STAFF REPORT
KETCHUM PLANNING AND ZONING COMMISSION
MEETING OF SEPTEMBER 15, 2020

PROJECT: 4th & Walnut Ave Commercial Development Design Review

FILE NUMBER: P20-046

APPLICATION TYPE: Design Review

A-201

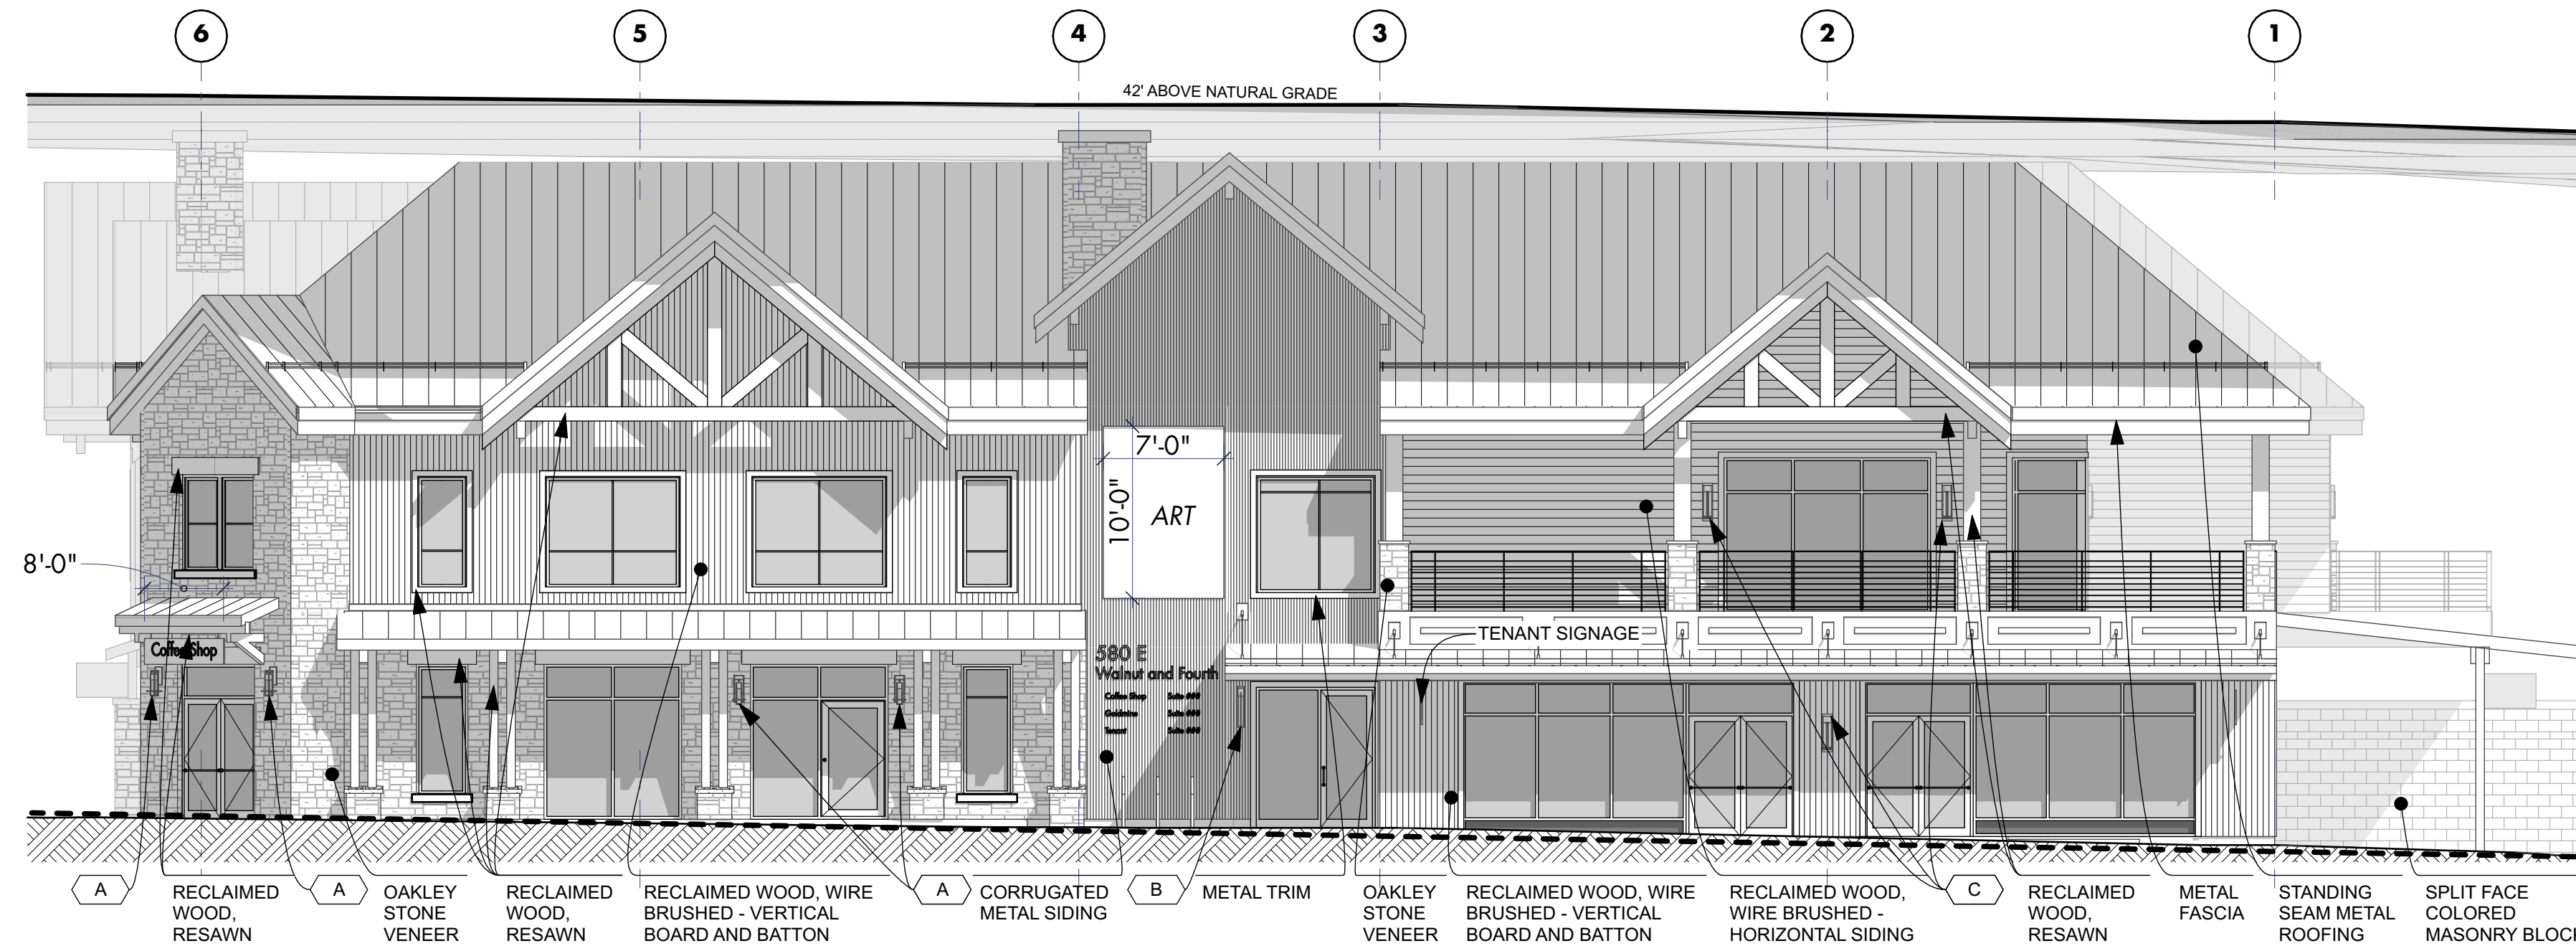
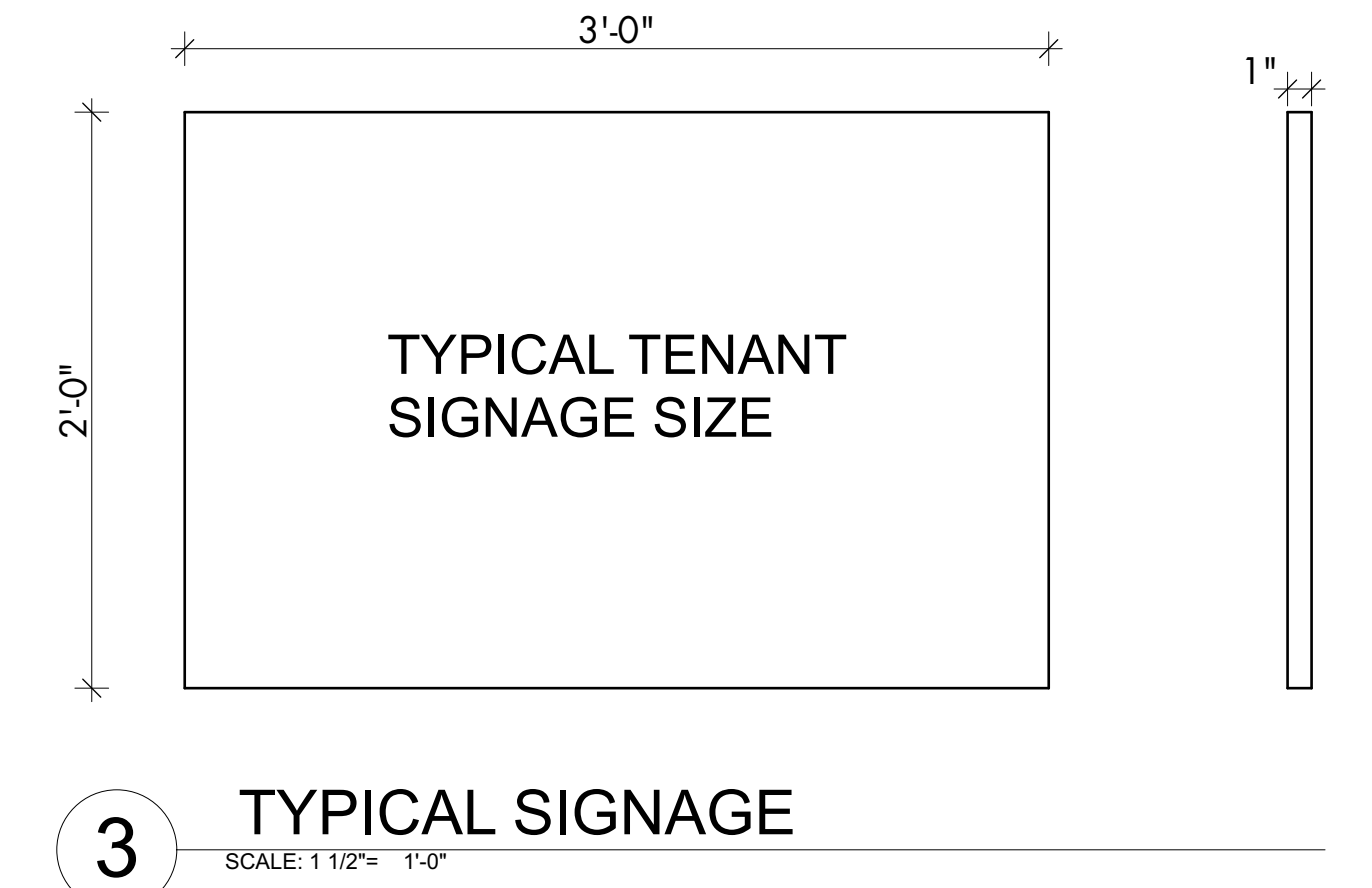
| | | | <i>Staff Comments</i> | <i>The elevations on Sheets A-201 and A-202 indicate the installation of snow guards that will provide weather protection preventing water from dripping or snow from sliding onto circulation areas. Canopy and overhang elements will serve as weather protection for pedestrians entering the mixed-use building and will shield the bicycle racks installed on site along 4th Street and at the rear of the building adjacent to the alley.</i> |

1 SE Elevation
SCALE: 1/8" = 1'-0"

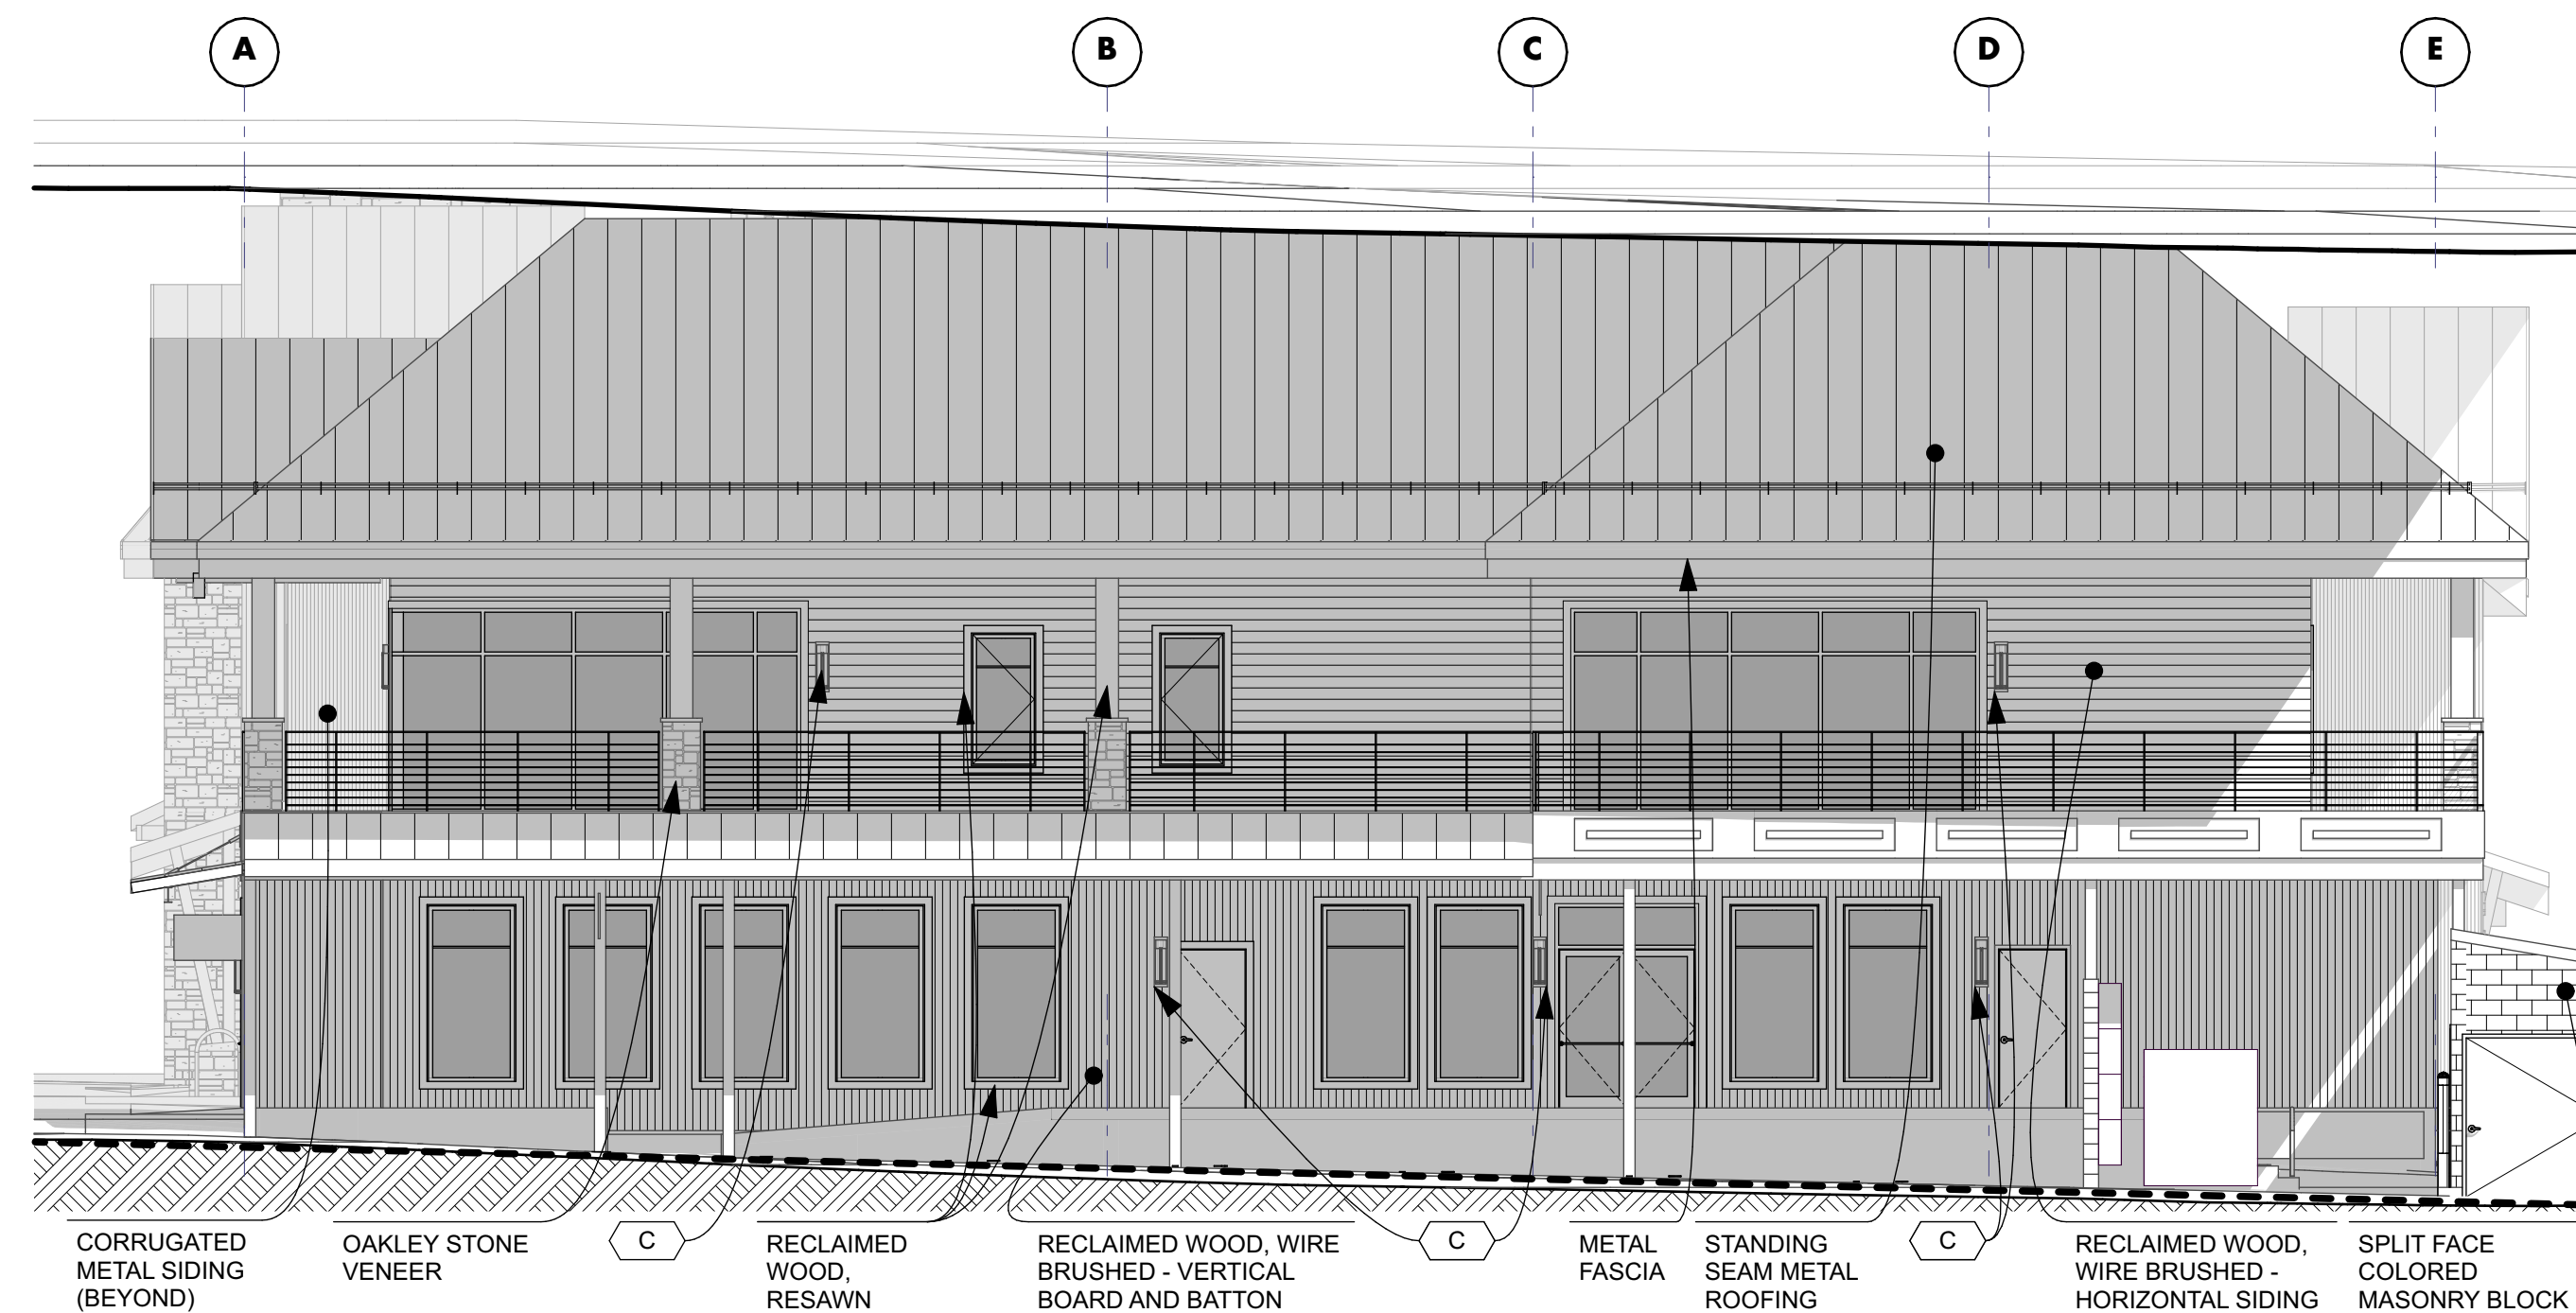
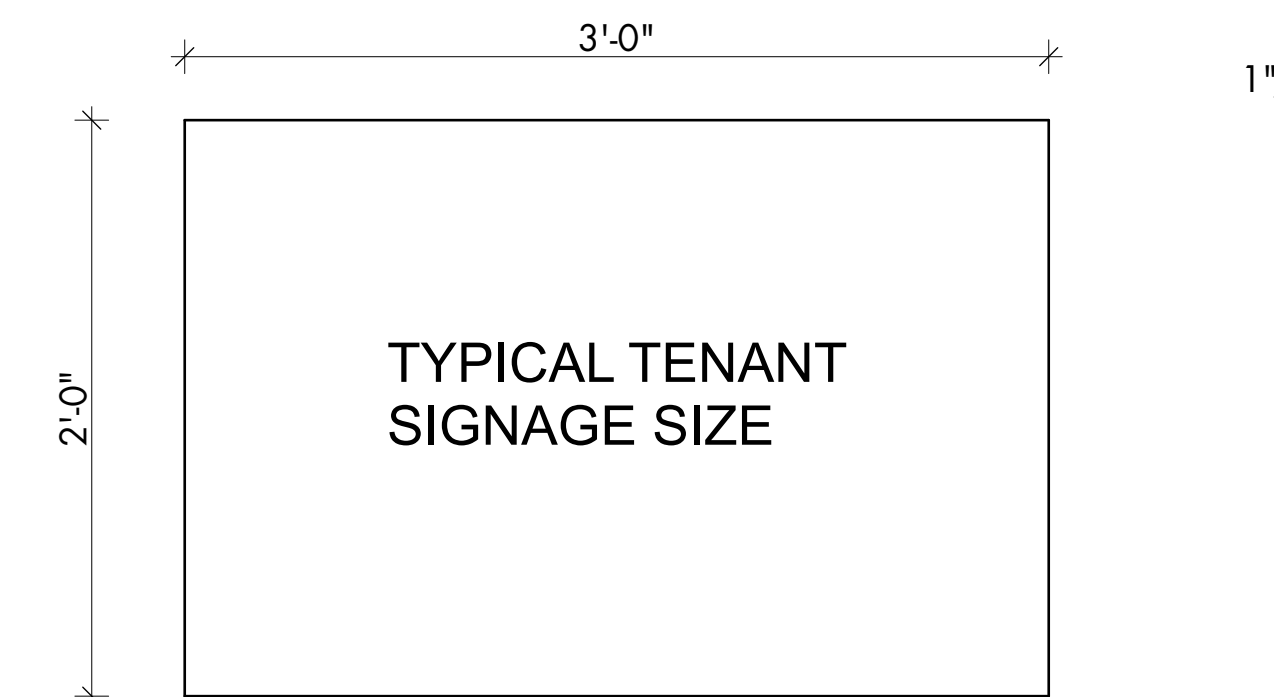
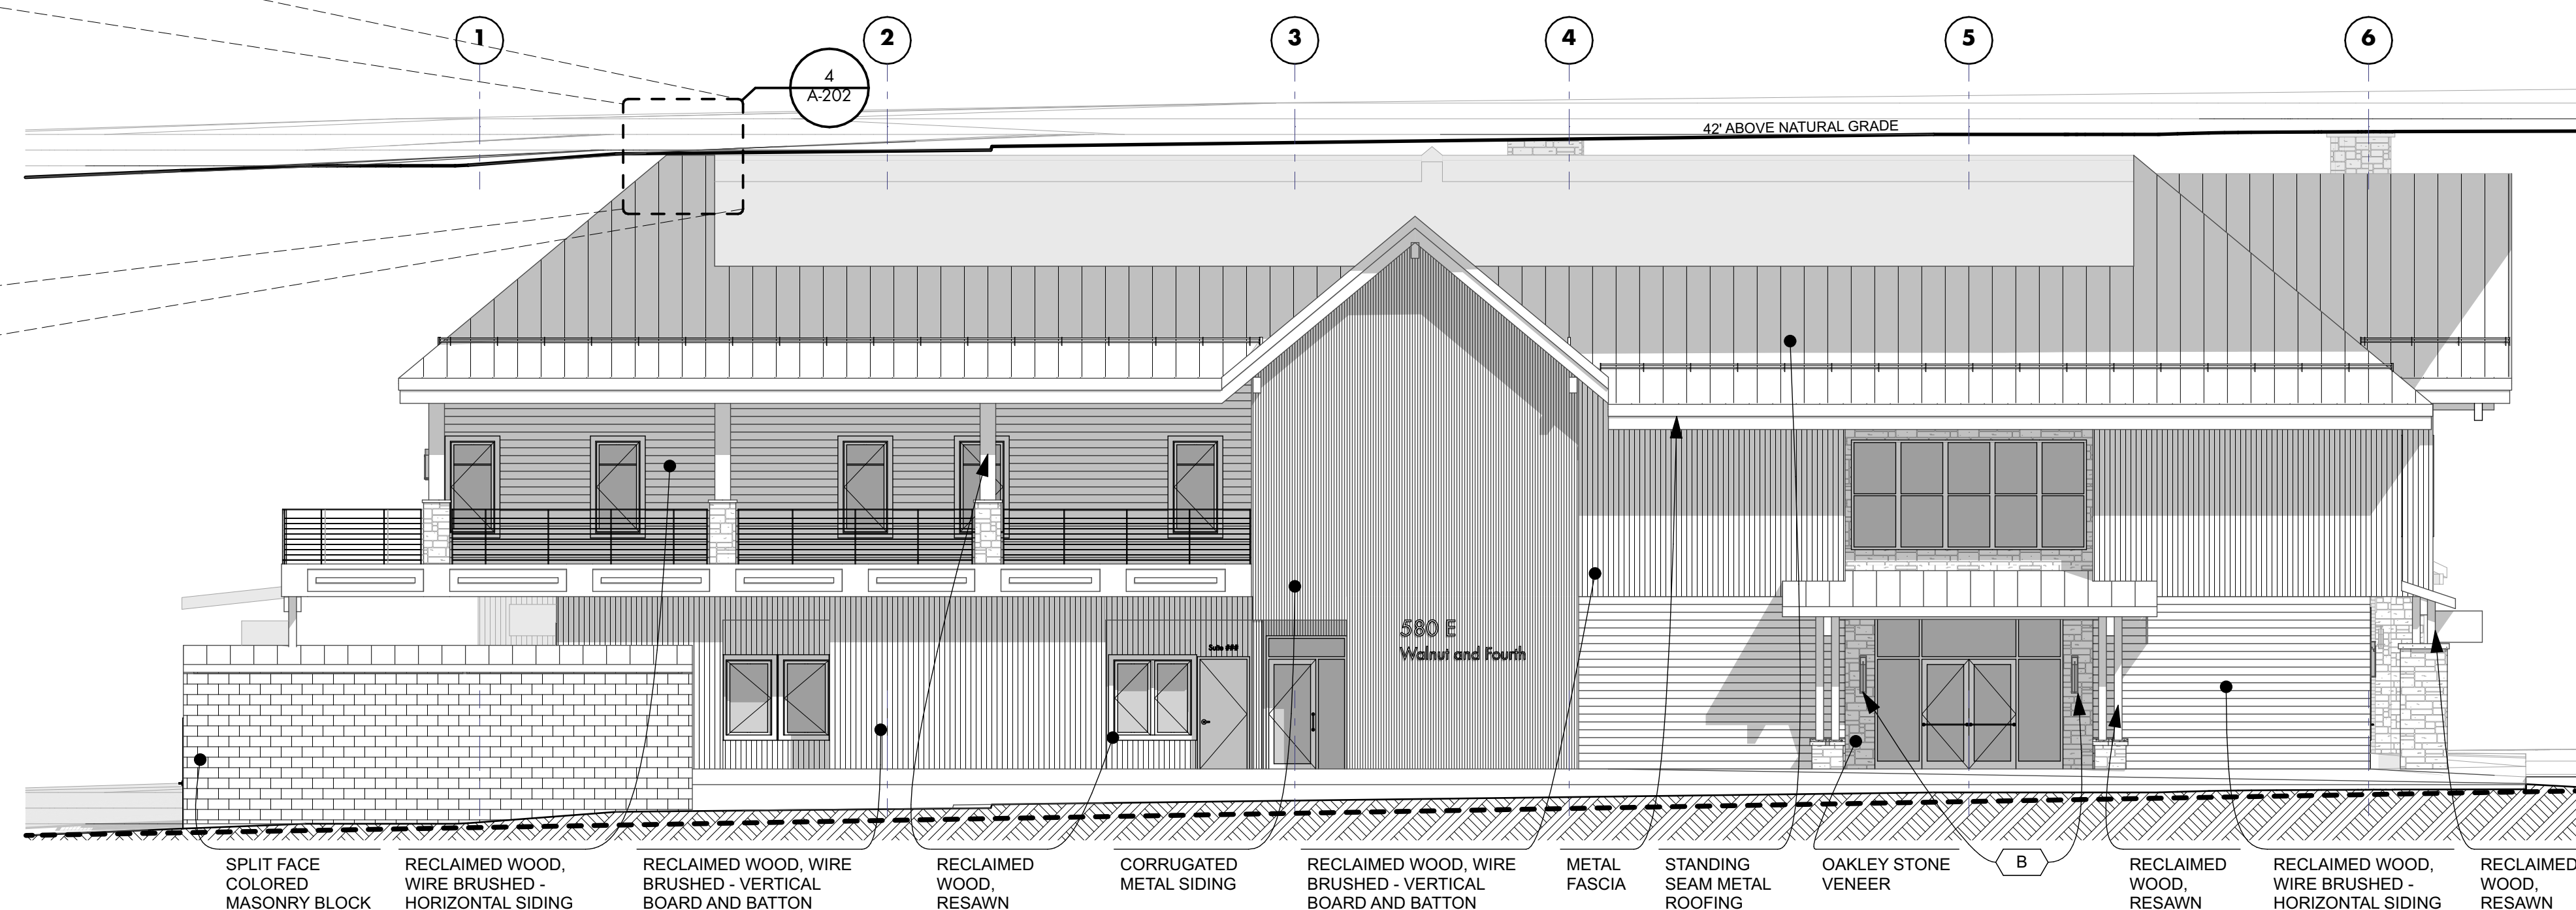
| | | | Staff Comments | <i>The proposed roof is a false mansard. As illustrated on the southeast elevation indicated on Sheet A-202, the top of the mansard roof falls into a 10-foot deep recessed area that is fully screened from public view. All roof-mounted mechanical, plumbing, and electrical</i> |

| | | | | <p>equipment is contained within this fully screened, false mansard recession. The applicant has also proposed a roof-mounted solar system contained within this recession.</p> <p>All utilities within the development site shall be underground and concealed from public view. The Architectural Site Plan (Sheet AS-101), First Floor Plan (A-102), and Alley Elevation (Sheet A-202) of the project plans indicate the electrical utility enclosure. The Architectural Site Plan (Sheet AS-101) indicates that the transformer serving the development will be located at the back of the building adjacent to the Block 44 alleyway and fully concealed from public view.</p> <p>An existing overhead power line runs along the Block 44 alleyway adjacent to the subject property. The project plans indicate that this power line will be buried underground.</p> <p>All roof and ground mounted mechanical and electrical equipment shall be fully screened from public view. The final screening, location, and height of all ground and roof mounted mechanical equipment shall be reviewed prior to the issuance of a building permit and shall be approved upon final inspection prior to Certificate of Occupancy for the project.</p> |
